LASER INTERFEROMETER GRAVITATIONAL WAVE OBSERVATORY

Document Type	DCC Number T080046-00-C	March 25, 2008
UK Upper Intermediate Mass Driver Pre-Production Prototype Bench Test and Evaluation		
Jay Heefner, Richard McCarthy, Josh Myers and Vern Sandberg

We report on the bench-test results and evaluation of the Advanced LIGO Suspension Upper Intermediate Mass Driver chassis (UIM) supplied as a pre-production prototype by the University of Birmingham. Bench tests were conducted in accordance with the test plan described in LIGO document T080021-00-C, “UK UIM Driver Pre-Production Test Plan”. A copy of the scanned version of the test plan evaluation results with bench notes is included in Appendix A of this document. The design requirements for the UIM Driver can be found in LIGO document number T060067-00-C, “AdL Quad Suspension UK Coil Driver Design Requirements”. We assume familiarity with these documents in the descriptions that follow. For reference, the relevant requirements for the UIM driver are listed below:

Fig. 14 Test setup to measure relay switching transients. An idealized version of the relay circuit are shown in the schematic on the left.

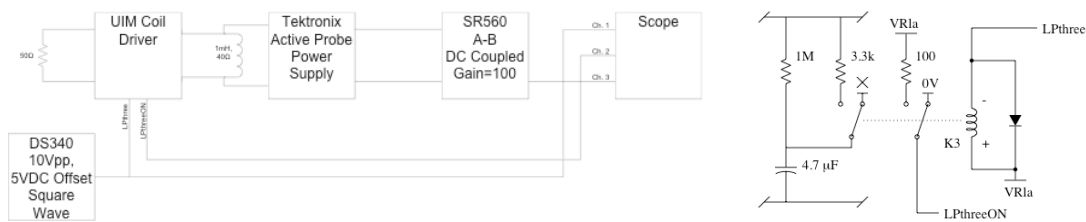
An attempt was made to measure any glitches or transients in the current output of the driver caused by the switching of relay K3. These tests are described and the results documented in section 3.4 of the test plan. During the tests glitches were observed across the load. The glitches were very small (50 mV) and fast (2 usec) impulses. They carried little energy, but were noted here for the sake of completeness. The switching time of the relays used on the board was found to be approximately 1milli-second and consistent from channel to channel. This is significantly better than the maximum 3 milli-seconds specified by the manufacturer of the relay. However, we do not have a sufficient lifetime test to determine the long term stability of the delay.

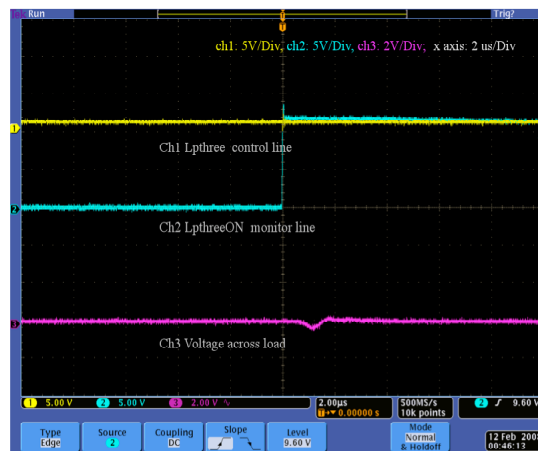
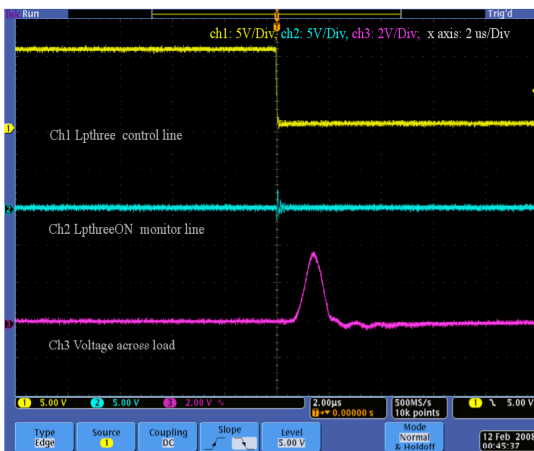
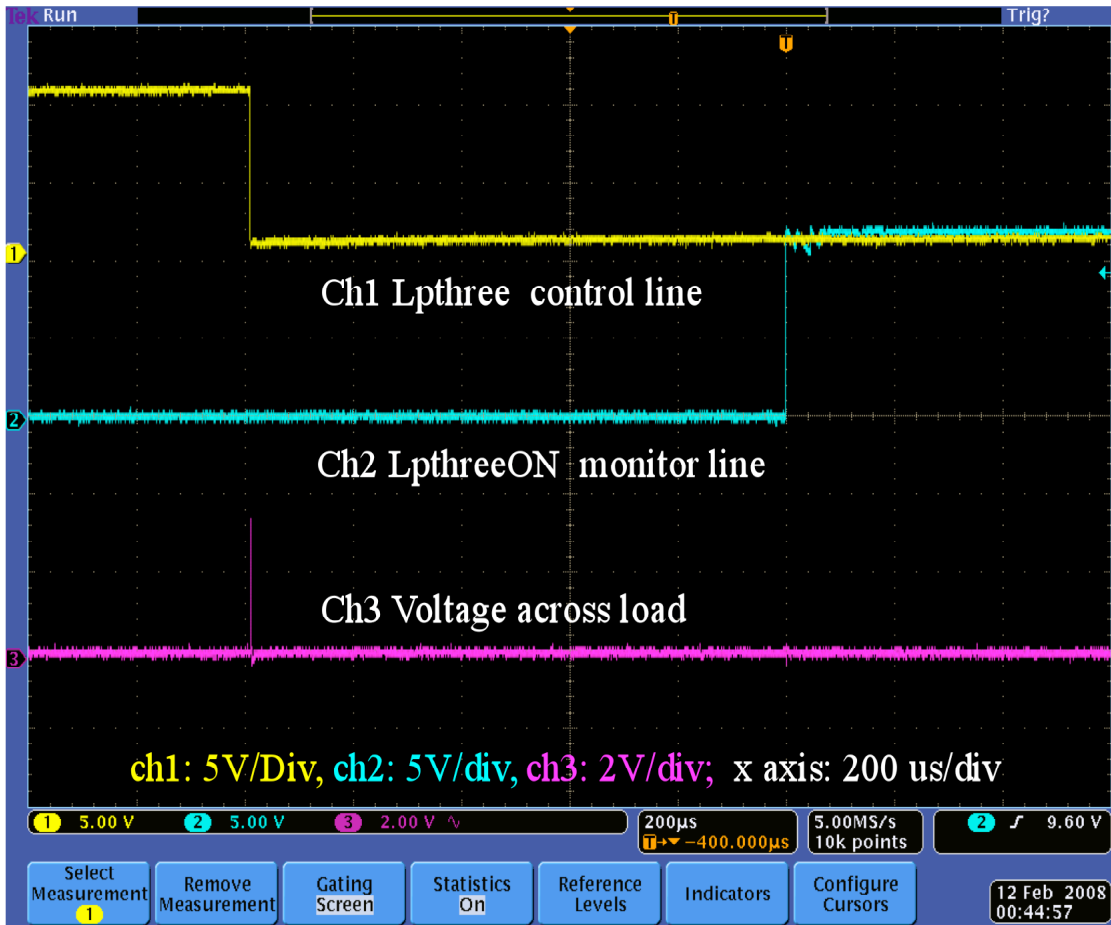
5. The switching speed of the relays is slow and raises the question of long-term stability of the delay time. From the time the drive signal is asserted to when the relay contacts close (measured using the readback circuit) was ~1ms. This action needs to be synchronized with a corresponding software-switched digital filter, which defines the meaning of simultaneity in this case. A long delay and any variation in that delay will be problematic and lead to stability problems in the overall control system. Since we are often trying to switch a digital filter simultaneously with the analog switch this could be a problem. We also noticed some ringing and contact closure bounces.

The oscilloscope traces shown in Fig. 15 illustrate the glitches that occur when the coil in the relay is energized and when the relay contacts close. For these tests the load was an 1 mH inductor with 40 ohms of equivalent series resistance. For investigating transients it was thought an inductor would be a more realistic choice for the load and highlight any glitches. The large frame image provides an overall view of what's going on and the time scale involved, 200 us/div. It takes 1msec for the relay to respond once you send a the signal to switch. The lower left image shows the first part of the switching process. Here you can clearly see the spike that's seen across the inductor. Taking into account the DC resistance and gain of the SR560 this works out to ~1mA of current through the load inductor. In the right image there's a smaller transient when the relay contacts actually close, but it's considerably smaller than the first one. Because we see this before the relay actually engages we believe we are seeing a transient from the relay coil charging, but these explanations are preliminary. The relay contacts chatters quite a bit when it closes. This is in addition to the glitches from the coil energizing.
